# DETAILED CONSERVATION COMMISSION AGENDA

Date: Thursday, January 27, 2022

### 1. (7:00) 152 Suffolk Rd – NOI – backyard pool, sports court, patio, and greenhouse – DEP #239-911

**5. (8:15) Hammond Pond Parkway – NOI – roadway and corridor improvement -- DEP #239-???**

LANDSCAPE PLANS 7  
NOTICE OF INTENT PLAN SET

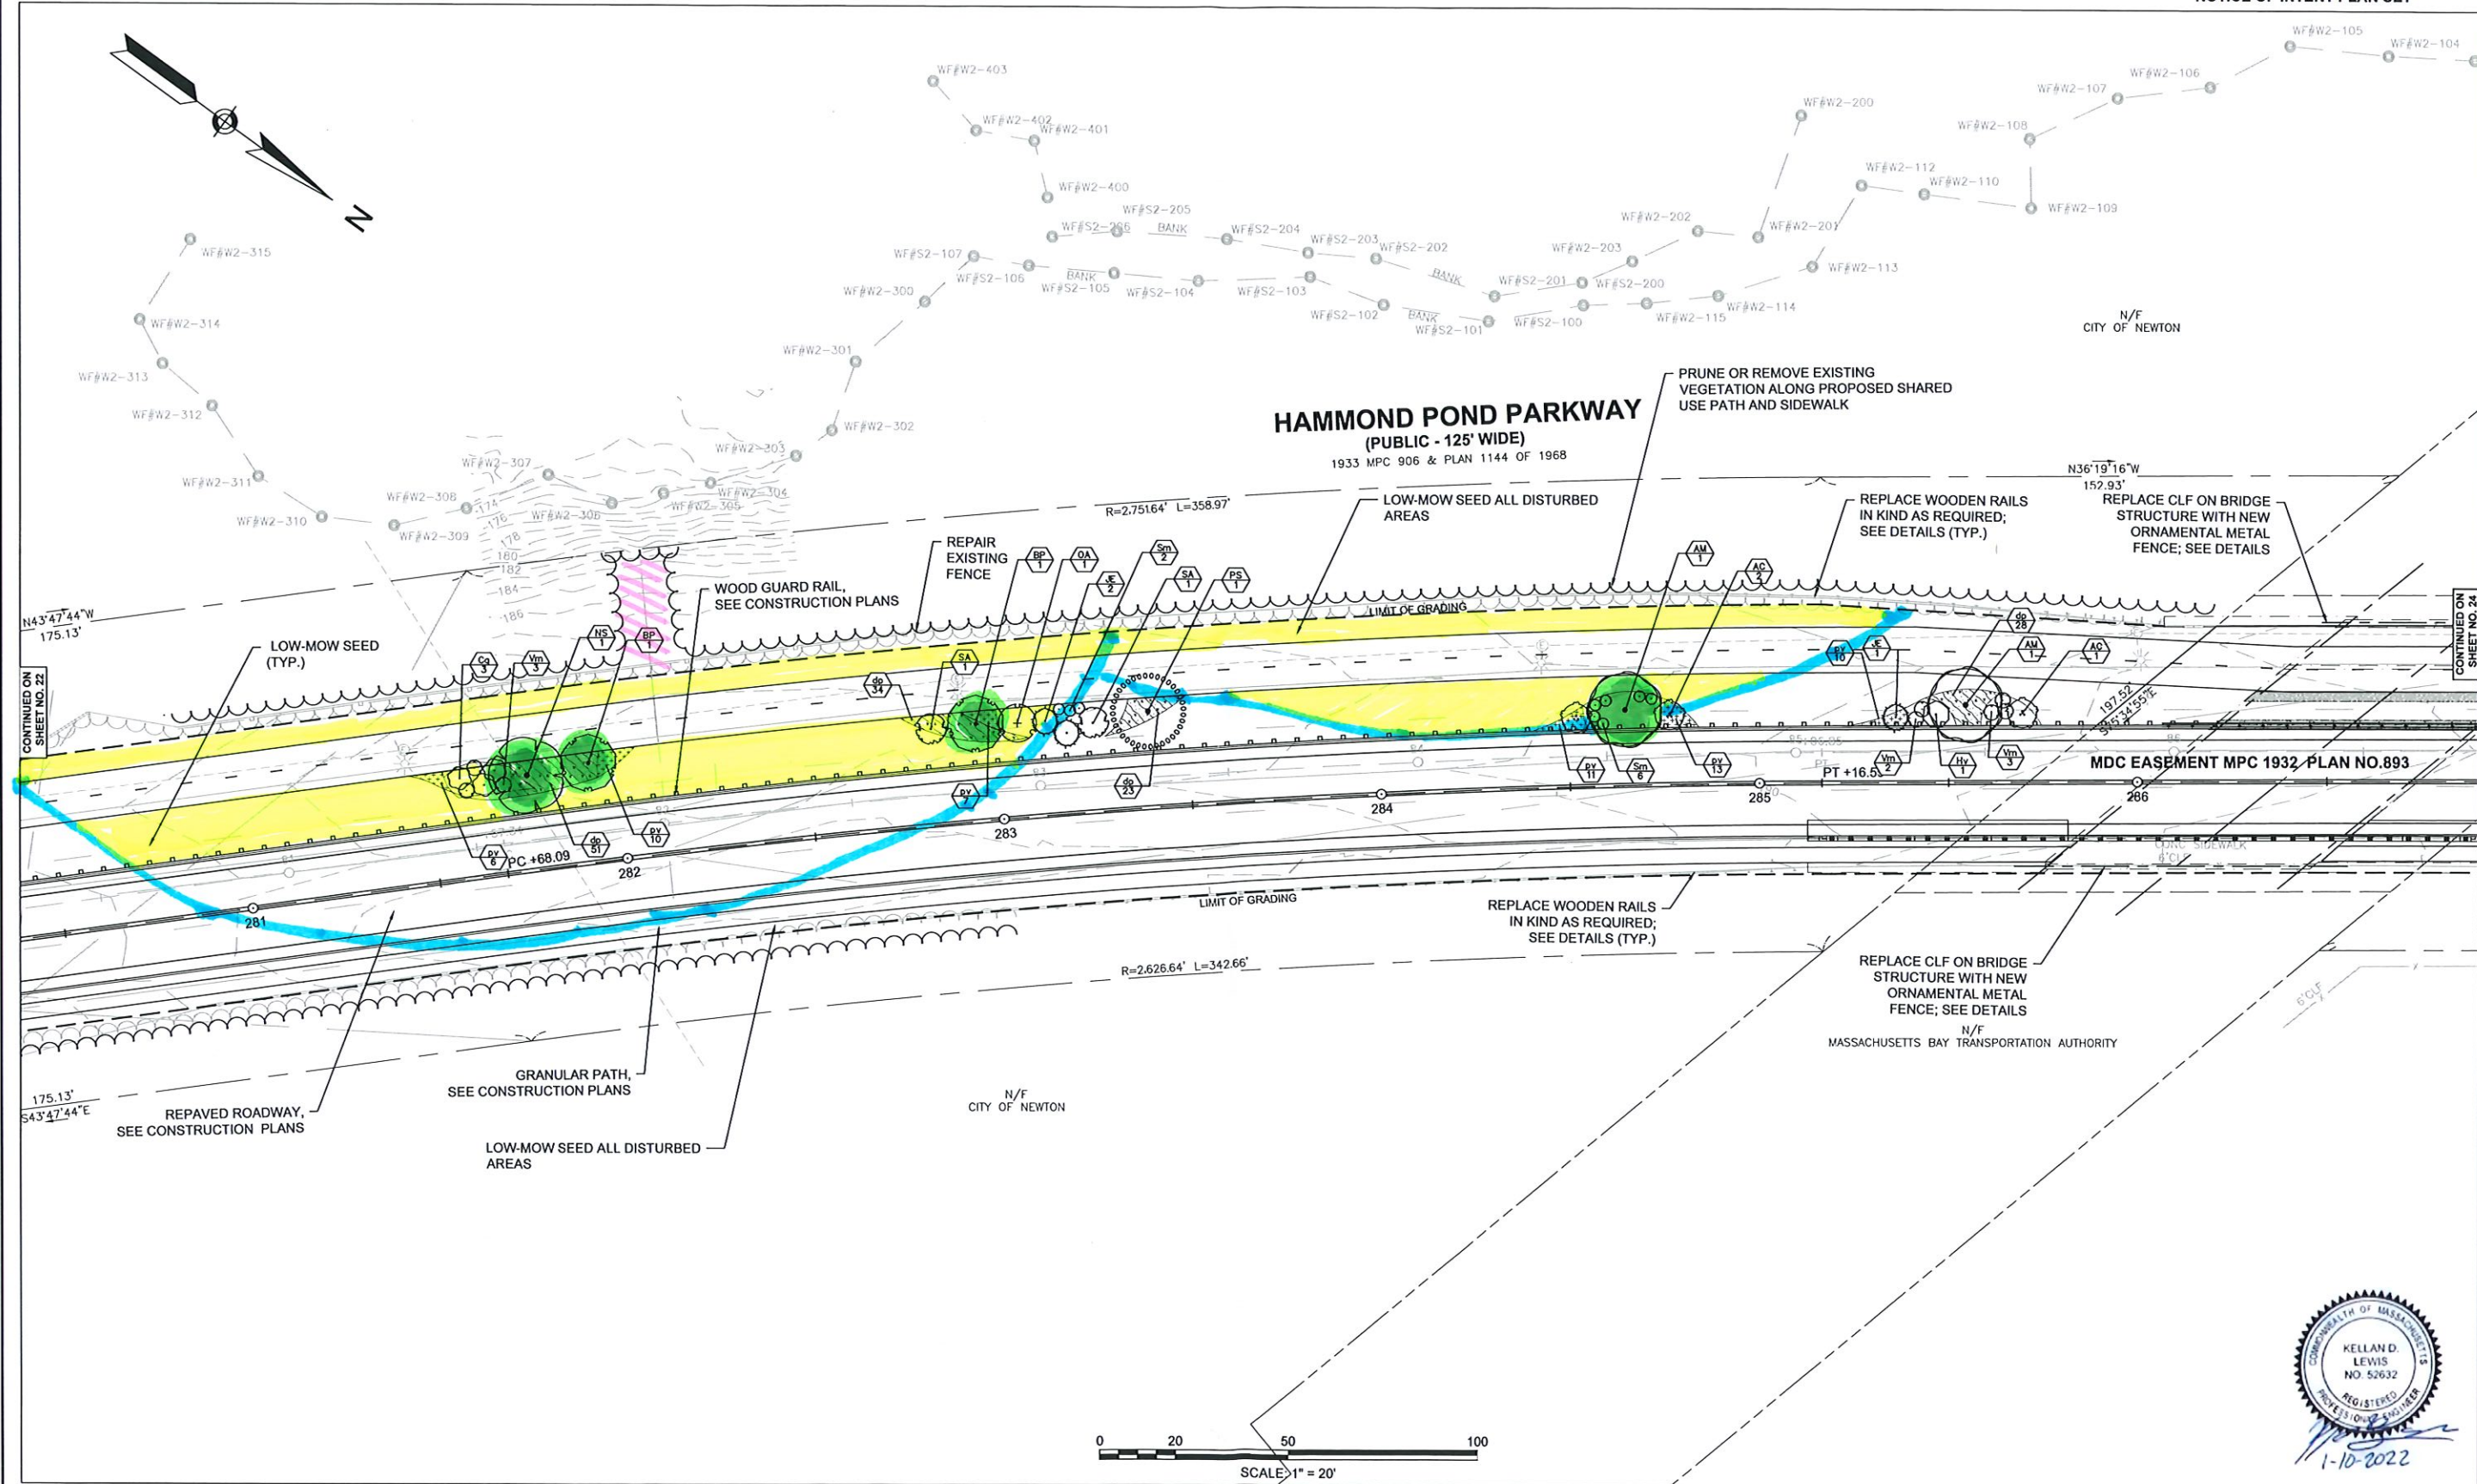
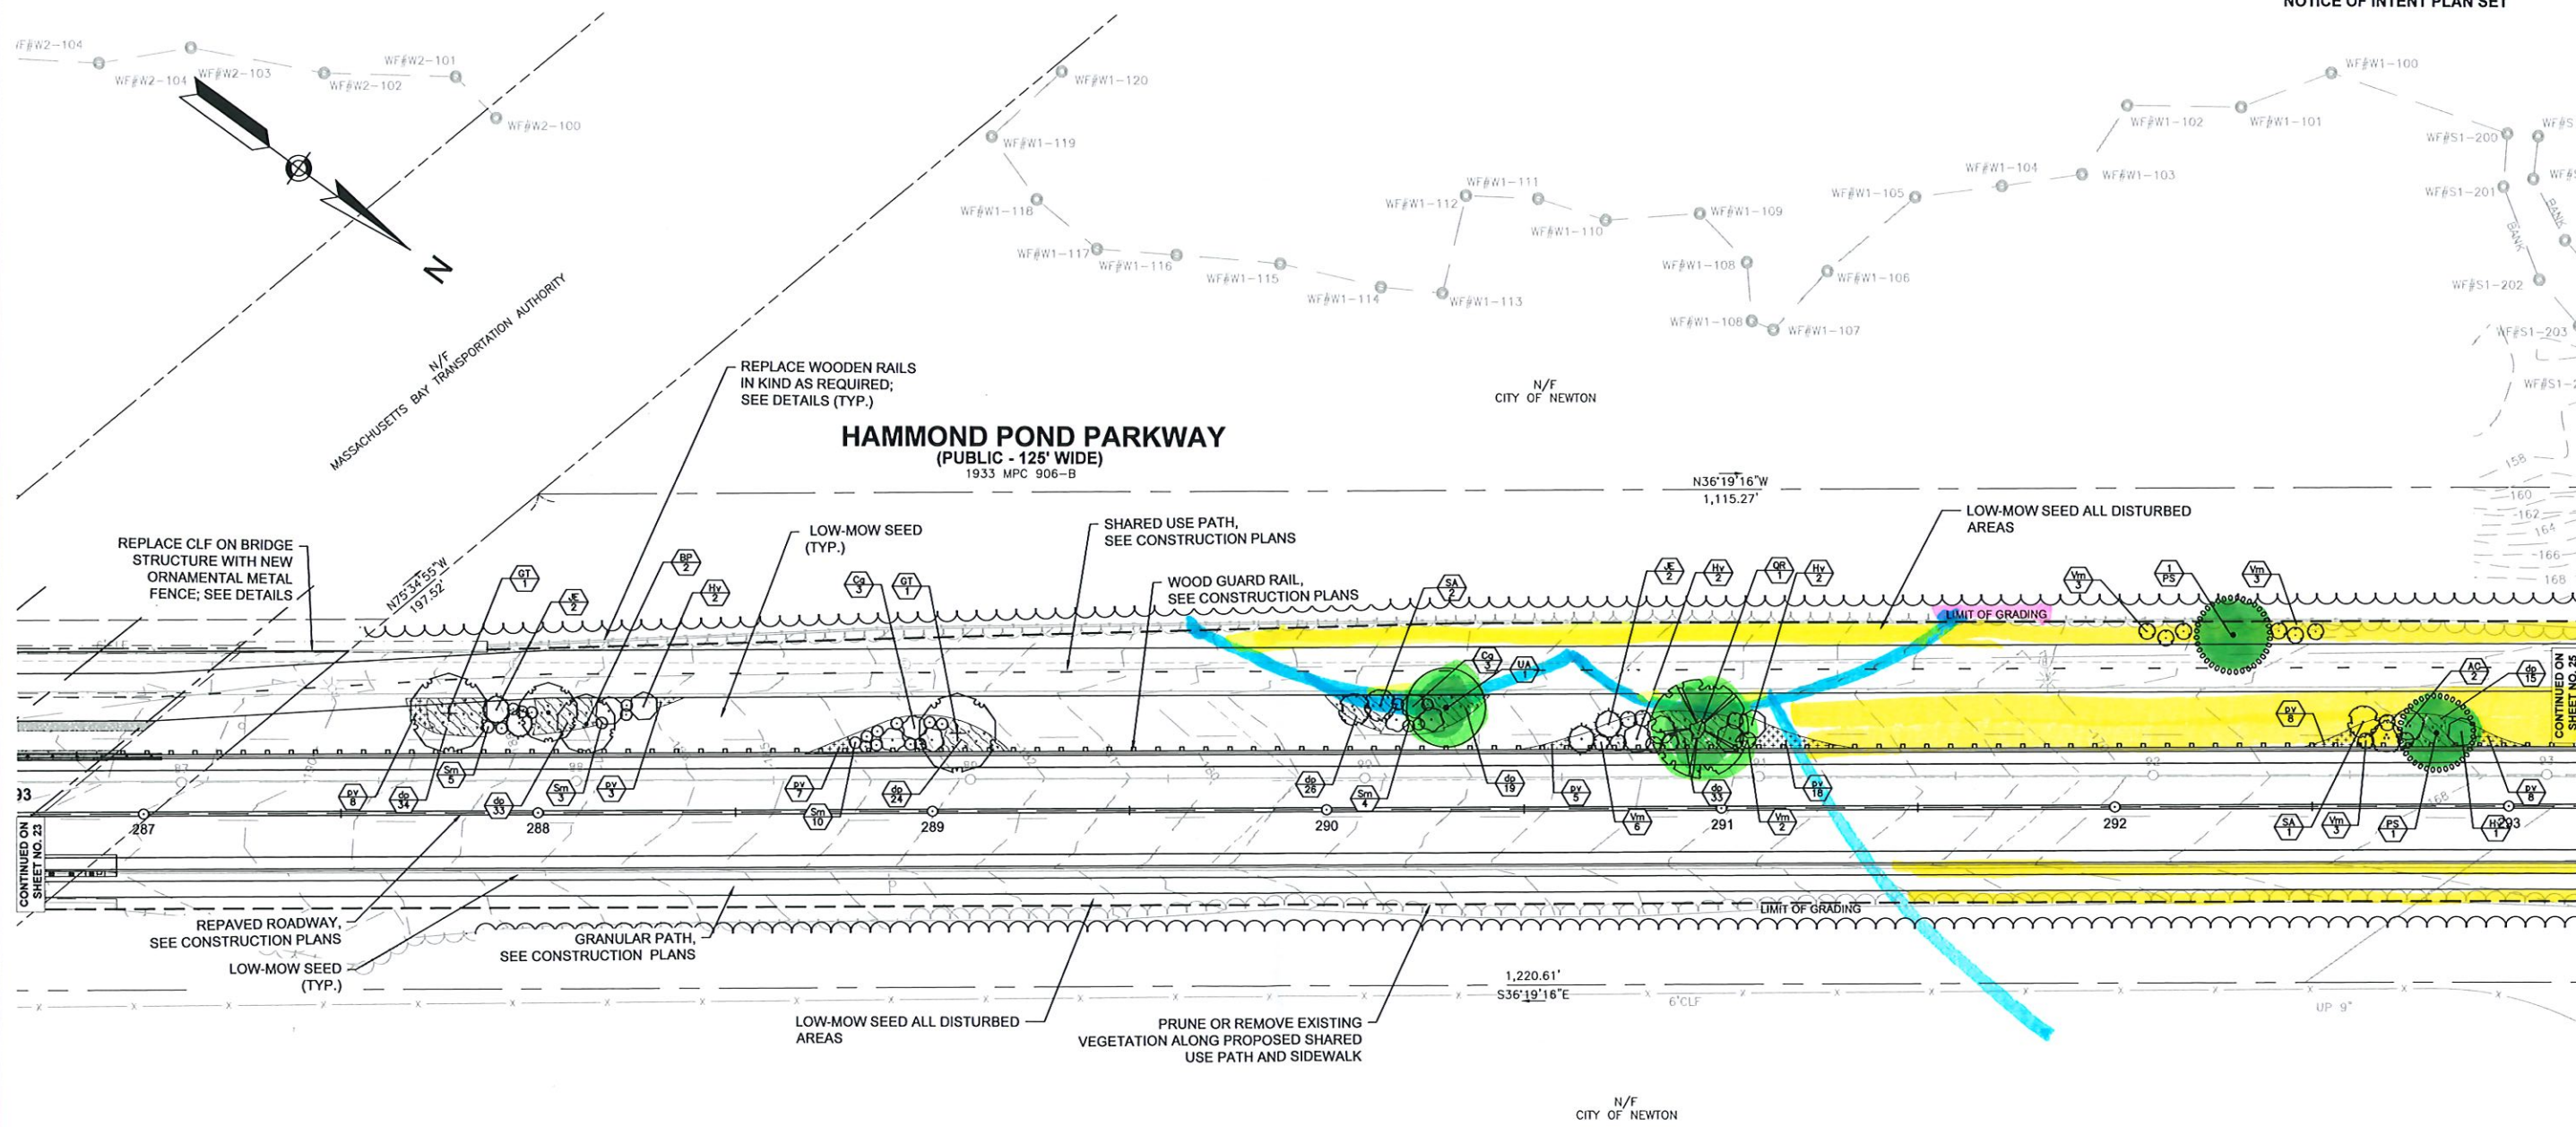
- There will be significant grading at the northeast corner of the new parking area, yet no new grade lines are shown and it appears that insufficient space is provided for side slopes. How will this area be addressed?
- On Landscape Plan sheet 5 there is a “limit of grading” label that appears to be on the property line. It should be removed.
- There is no erosion control/limit of work shown that would protect the “island of trees” near Hammond Brook. That should be added.
- Will there be any invasive control efforts?
